CITY OF MORRO BAY CITY COUNCIL Agenda

- II. APPROVE WRF CONTRACT AMENDMENTS AND REVIEW AND COMMENT ON FISCAL YEAR 2023 QUARTER 3 WRF QUARTERLY REPORT; (PUBLIC WORKS DEPARTMENT)

SUBJECT: Approve WRF Contract Amendments and Review and Comment on Fiscal Year 2023 Quarter 3 WRF Quarterly Report

City of Morro Bay
Water Reclamation Facility
Lift Stations and Offsite Pipelines Project
CHANGE ORDER 008

Figure 5-1: WRF Site Access Road – NOT USED – See 90% Drawings [PCO 066]

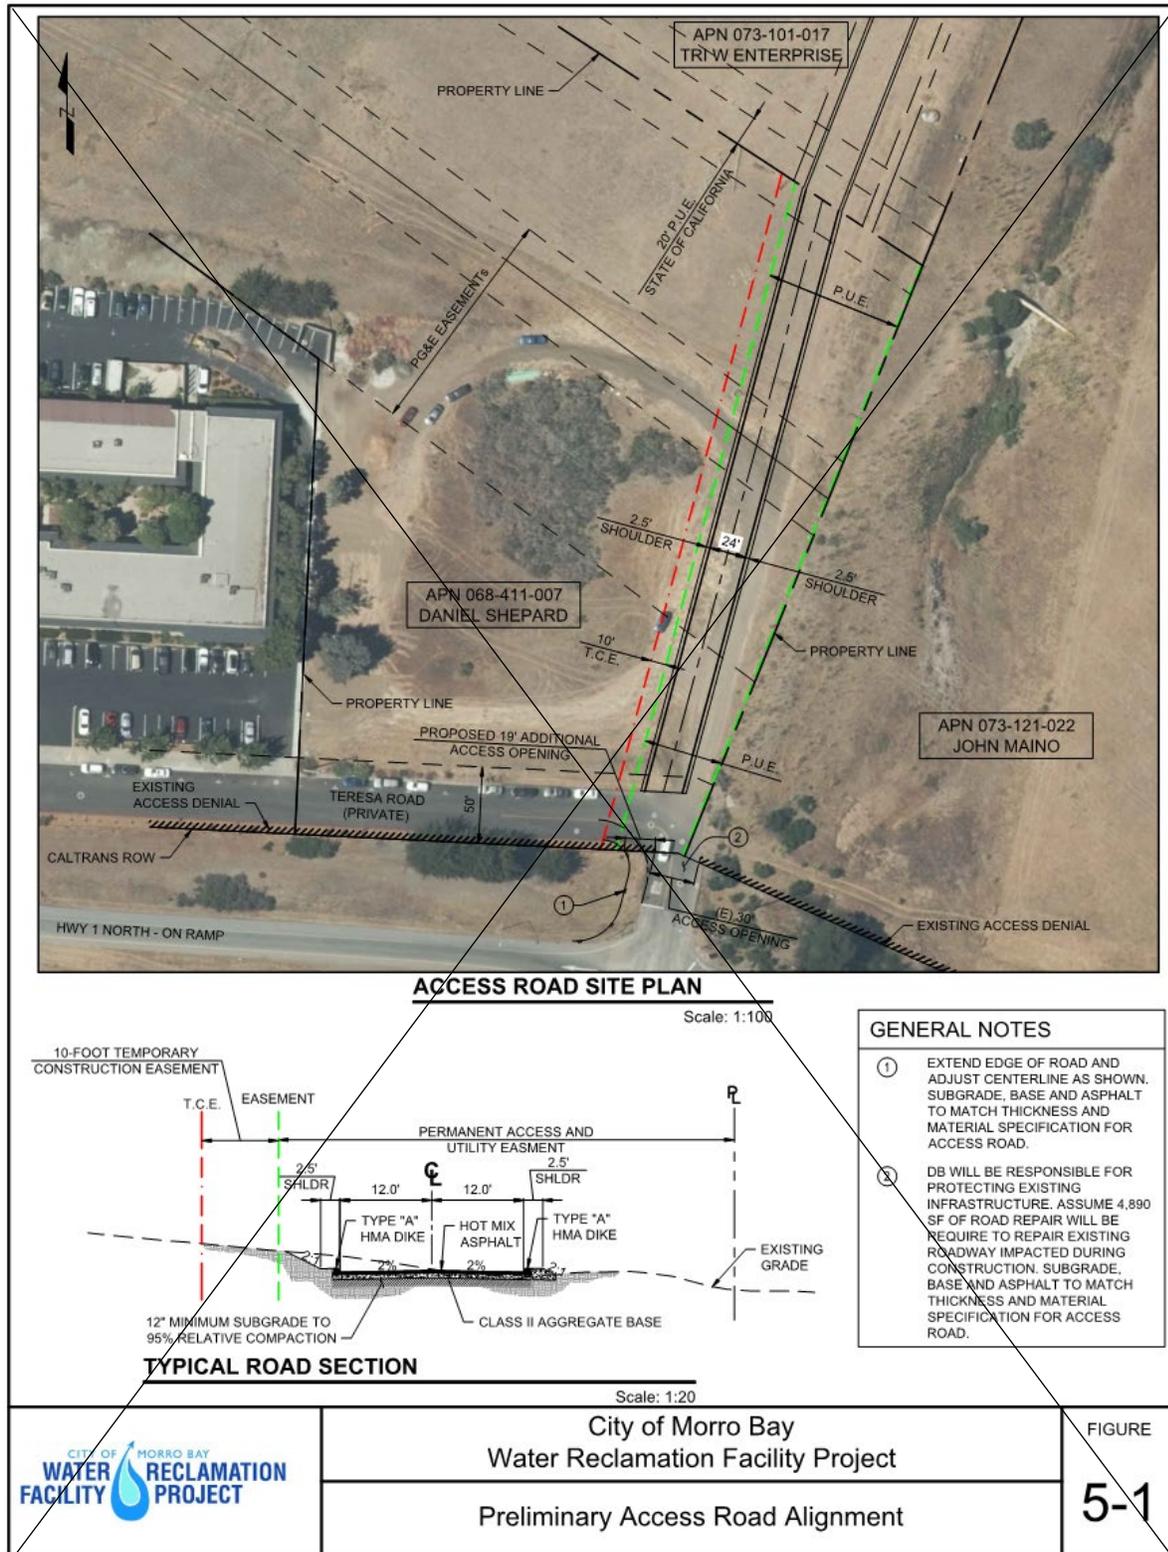
[PCO 066]
